SOCIAL IMPACT ASSESSMENT ADDENDUM LETTER

Calala Battery Energy Storage System (BESS)

This statement relates to the amended Calala Battery Energy Storage System (BESS) (SSD-52786213) at 474 Calala Lane, Calala (Lot 17 DP 629969). On behalf of The Trustee for Equis Energy (Australia) Ngumi 4 Holding Trust (the Applicant), this Social Impact Assessment (SIA) Addendum Letter has been prepared to support the submission of the revised Calala BESS SSD application.

Figure 1 Amended concept plan

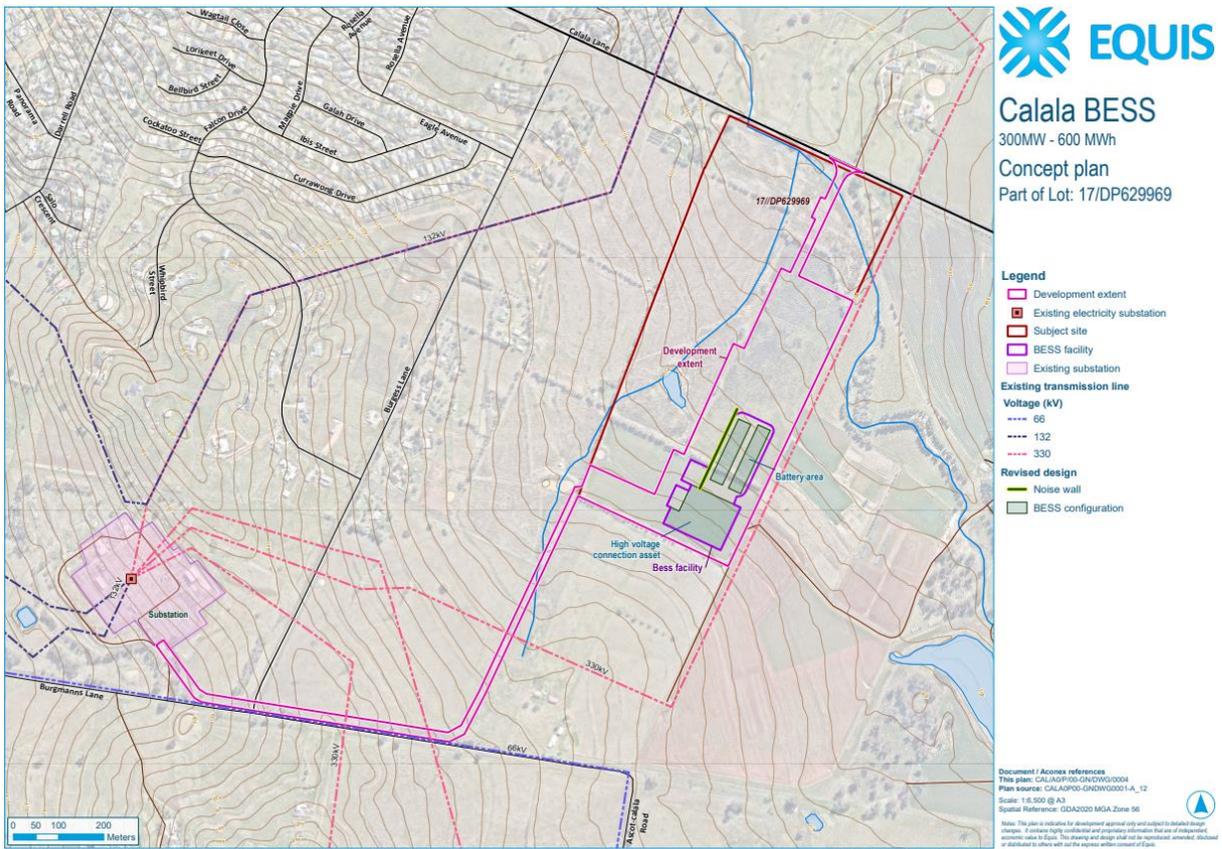
The following section provides a summary of the key changes proposed for the amended Calala BESS (Table 1) and the amended site plan (Figure 1).

Original proposal	Changes proposed	Improved design response
Battery type		
Wartsila and SMA battery technology	Tesla Megapack 2XL	The OEM offers a fully integrated product with a smaller footprint, no need for auxiliary distribution infrastructure, a high track record of delivering projects on time, and proven grid-forming services beneficial to the NSW energy transition.
Battery enclosures and associated equipment

Original proposal	Changes proposed	Improved design response
960 battery storage enclosures 120 inverters and transformers 6 Ring Main Units (RMU) and auxiliary transformers	164 battery enclosures, 82 transformers, 16 Ring Main Units (RMU)	Fewer battery enclosures and battery area footprint reduced by approximately 60%
Battery enclosures 2.8 tall x 3.2m wide. Colour matt grey or other rural landscape colour in matt finish. Pre-fabricated Colorbond cladding	Battery enclosures approx. 2.8m tall x 1.6m wide. Colour white. Prefabricated cladding material.	Smaller battery enclosures.
Output rated capacity		
300 MW	300 MW	No change
Storage duration		
4-hour battery	2-hour battery	Reduced BESS storage capacity Reduced footprint
Max. amount of Stored energy		
1,200 MWh	600 MWh	Reduced BESS storage capacity Reduced footprint
Noise Attenuation Walls		
4m tall northern noise barrier	Deletion of northern noise barrier	Reduced visual impact

4m tall nearfield HV transformer noise barriers	Deletion of nearfield HV transformer noise barriers	Improved internal accessibility and reduced visual impact
Setbacks and screening		
Southern boundary trees retained but no additional landscaping or screening	5m landscape strip along southern boundary planted with new vegetation screening	Improved landscape screening and reduced visual impact
No earth mound. Greater visibility of noise wall.	Grassed earth mound approx. 130m long and up to 5m tall, located west side of western noise wall	Improved landscape screening and reduced visual impact

Original proposal	Changes proposed	Improved design response
Transmission line along southern boundary (Lot 17 - BESS site)	Transmission line setback 33m from southern boundary	Creation of landscape setback and screening described above, reduced visual impact
37m north APZ 26m east APZ 10m south APZ 22m west APZ	10m north APZ 25m east APZ 20m south APZ 10m west APZ	Project footprint economised to align with policy requirements.
Tamworth substation connection		
Underground cable connecting to the existing Tamworth substation	Connection to Tamworth substation includes associated substation augmentation and ancillary works as required.	Connection alignment to the substation remains unchanged.
Civil works		
Construction laydown in 2 separate locations	Construction laydown area combined and repositioned, temporary stockpile area added.	Improved internal accessibility
Significant amount of benching. Excess soil disposed offsite.	Benching reduced and soil retained onsite.	Soil retained onsite. Grassed landscape mound along western interface.
